Re: Indian Point Unit No. 2
Docket No. 50-247
NL-00-095

Subject: Responses to the NRC's Request For Additional Information Regarding
Steam Generator Operational Assessment Report (TAC No. MA9288)

Response to RAI Question 3 from NRC Letter Dated July 3, 2000

Figure RAI-3-1

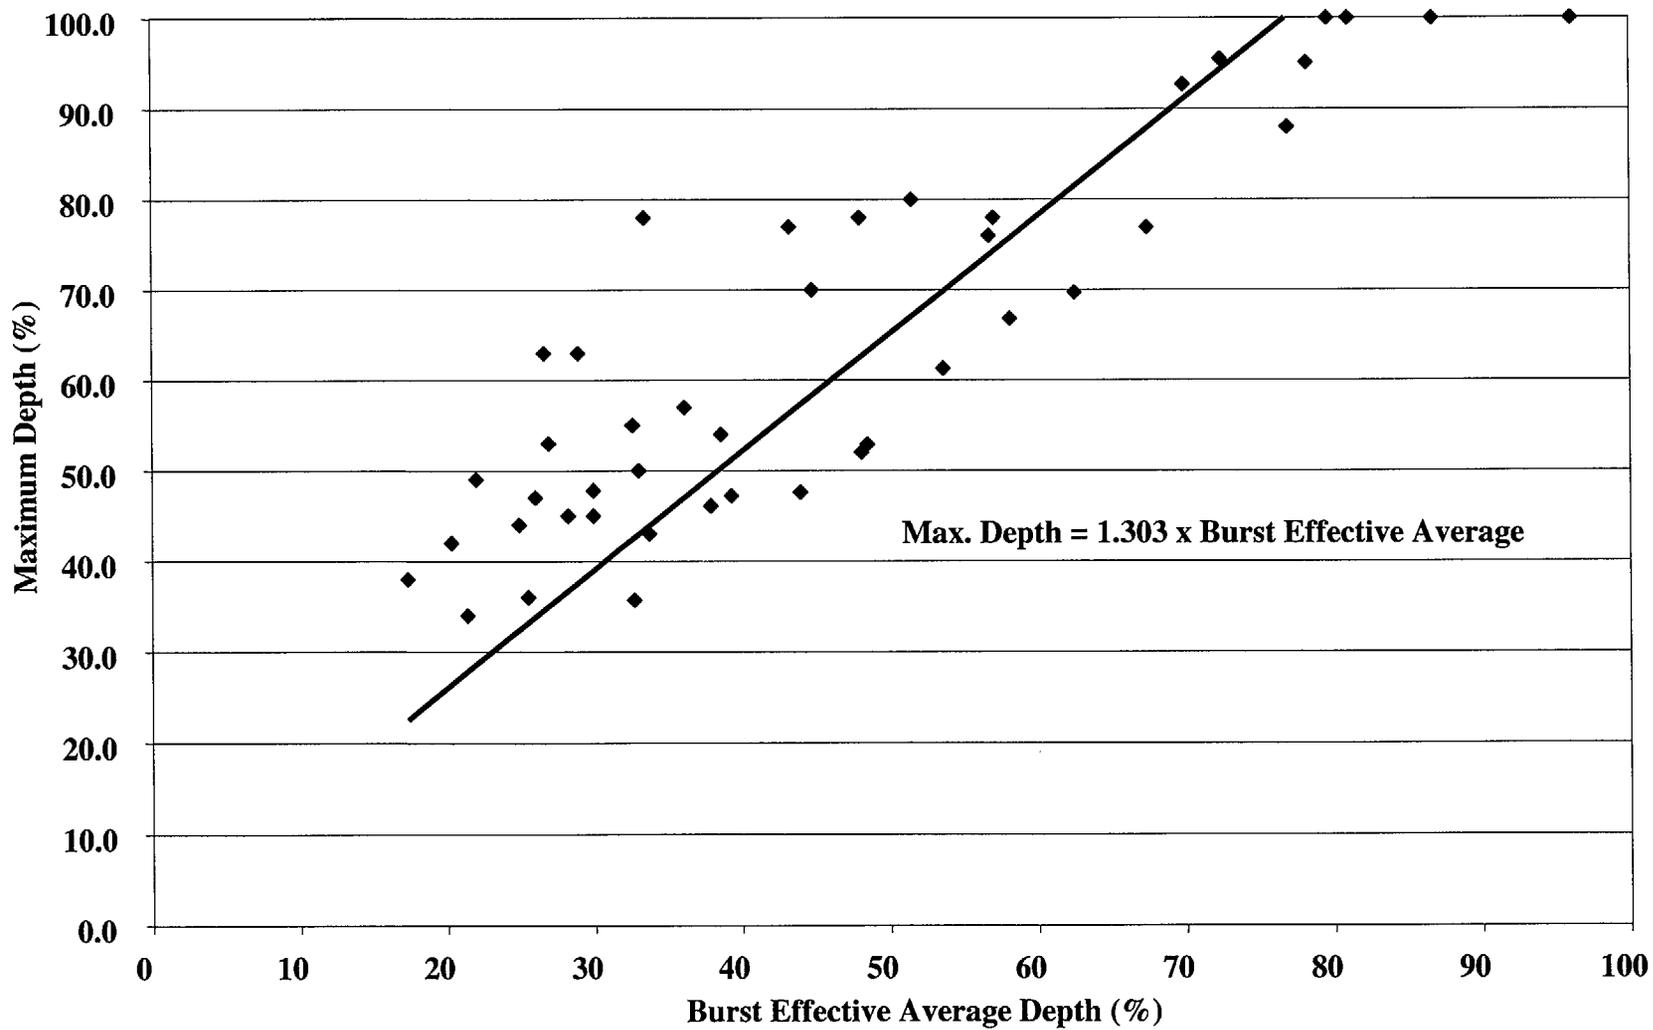
- d. *Discuss how the correlation of 1.257 between maximum depth and burst effective average depth applies to data not from IP2.*

An analysis was performed, using available pulled tube data from other operating plants for ODSCC in the freespan and sludge pile, to further evaluate the applicability of the 1.257 ratio of the maximum depth to the burst effective crack length average depth. Table RAI-3-1 (below) includes the data that were used in this analysis. Figure RAI-3-1 (below) shows the ratio between the maximum depth and the average burst effective depth to be 1.303. The most appropriate value of the maximum average ratio to use is that based on IP-2 specific data, 1.257. This results in a more conservative POD value as discussed below.

The POD curve for average depth is derived by dividing the maximum POD curve values

by the maximum average ratio. The result is to shift the POD curve to the left (e.g., Figure 4.2-3 of SG-00-06-010) of the recommended POD curve. Consequently, the recommended POD curve, based on the ratio of 1.257, is more conservative than the POD derived from application of the larger maximum average ratio of 1.303.
